August 31, 2016

**Re: NIRB File No. 11EN010 Application No: 124668 – Opportunity to address comments received regarding Agnico Eagle Mines Ltd.’s “Amaruq Exploration – Portal/ Ramp, Quarry and Advanced Underground Exploration and Bulk Sample” project proposal**

Update to Golder (2016) - Figure 2: Carbonate Neutralizing Potential vs Acid Potential – Ramp and Portal Samples

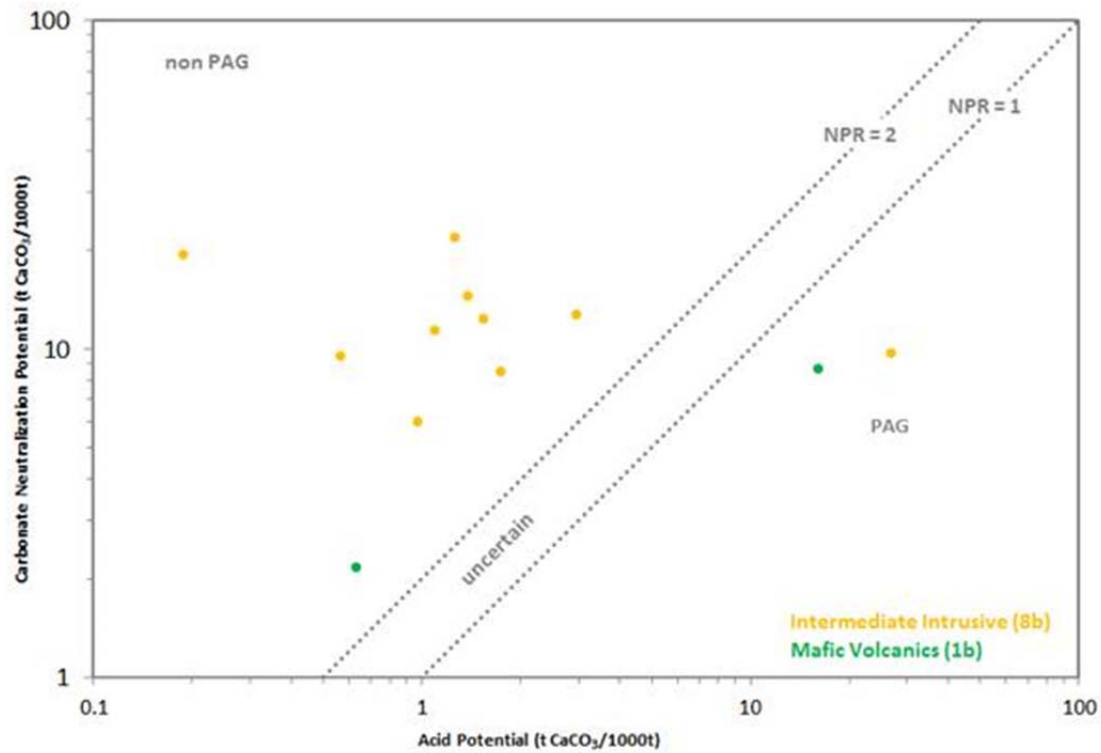
### **4.4 The analyses of the rocks closer to the deposit within the development of the ramp should not be limited to arsenic, but include other metals of concern. Further, the geochemical database for PAG and non-PAG rock should be expanded for several elements to better determine the extent and significance of leachable metals within all rock types.**

Agnico Eagle appreciates the feedback from ECCC and KIA and below has updated Figure 2, page 7 of Golder (2016) Evaluation of Geochemical Properties of Waste Rock from the Underground Ramp, Whale Tail Underground Deposit, Amaruq Project. Agnico Eagle agrees with the comments and will continue to expand the geochemical database of kinetic and static testing to better determine the extent and significance of leachable metals within representative rock types. It is important to note that the ramp is deliberately designed to be within geotechnically stable, NPAG, non-metal leaching material (Intermediate Intrusive and Mafic Volcanic). Only a small proportion of the underground development will generate ultramafic and iron formation waste rock, which have the highest risk for arsenic leaching but also have a low potential for acid generation. Furthermore, the number of samples collected specifically targeted areas within area of the ramp to meet standard statistical approach for the

The sampling plan also considered the much larger dataset obtained from the characterization of waste rock from the open pit. As demonstrated in Figure 6 on page 12 of Golder (2016), there is a clear distinction between lithologies that provides confidence in our ability to predict NPAG vs PAG. The dataset for greywacke from the underground development shows two distinct populations of samples: samples that have a high sulphur content and low buffering capacity which are PAG and samples that have noticeably higher carbonate buffering capacity and very low Sulphur content which are NPAG. This pattern is also observed in the larger geochemical database for the deposit where greywacke has higher sulphur content in close proximity to the ore zone whereas greywacke located at a further distance from the ore zone is generally non-PAG and with low sulphur content. A sulfur content cutoff of 0.2% is proposed to distinguish between PAG and NPAG rock which may be overly conservative for greywacke in the underground development where a lower value of 0.04% could potentially be considered. Accordingly, the greywacke lithology is considered to have a variable ARD potential depending on the location of the material with respect to the ore zone. This makes greywacke suitable for segregation during mining. These characteristics are consistent within each lithology whether samples are from the ramp, the underground development or the open pit areas.

APPENDIX FIGURE E-2.11

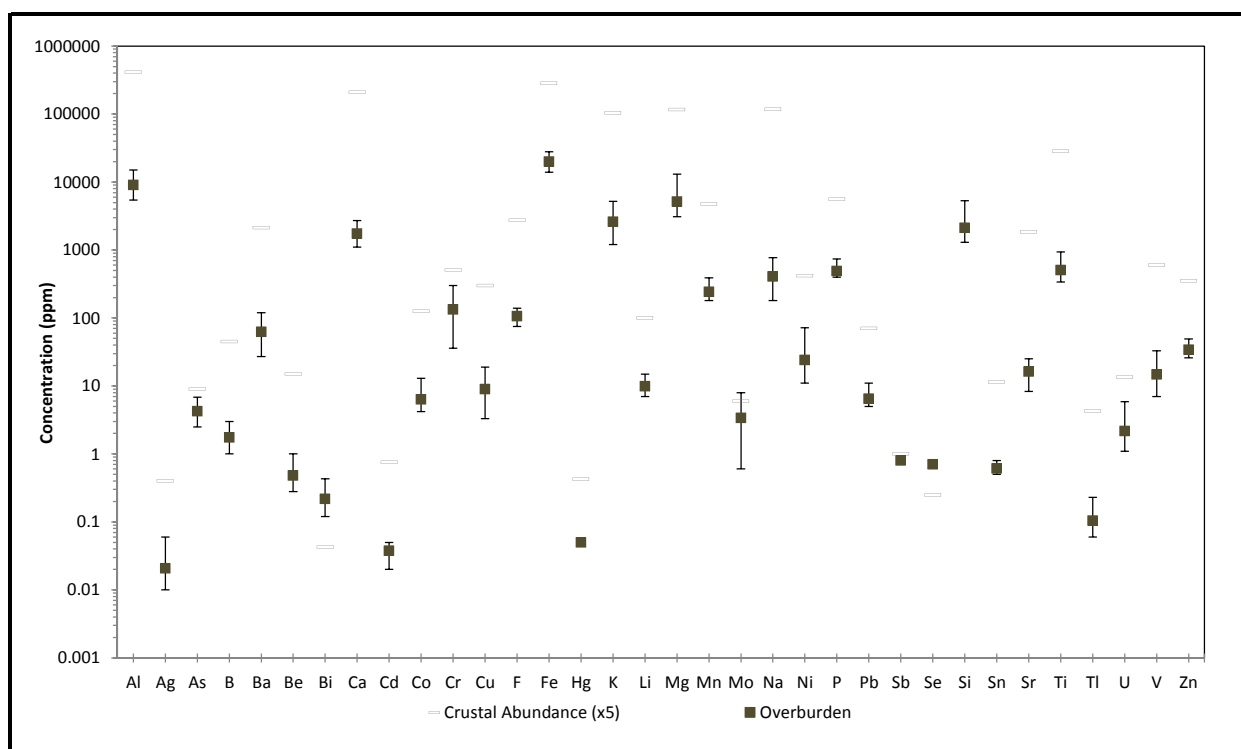
- i) Volumes for the rock quarry, services pad and operations pad,
- ii) Tonnage and rock volumes to be removed, and
- iii) Testing of the overburden material that would be used in pad construction.

Attached in Appendix A you will find a summary of the overburden geochemistry results from samples taken near the Amaruq Exploration Quarry and Portal/ Ramp in 2015. In total 12 samples were collected and analyzed in 2015. Additional samples of the overburden will be collected in 2016 in preparation of ramp development.

- i) Rock quarry volume – approximately 360,000 m<sup>3</sup>  
Service pad volume – maximum 63,432 m<sup>3</sup>  
Operations pad volume – maximum 85,012 m<sup>3</sup>
- ii) Tonnage and rock volume removed – 258,619 m<sup>3</sup>
- iii) Testing of overburden material is provided in Appendix A. Additional testing will be undertaken in 2016.
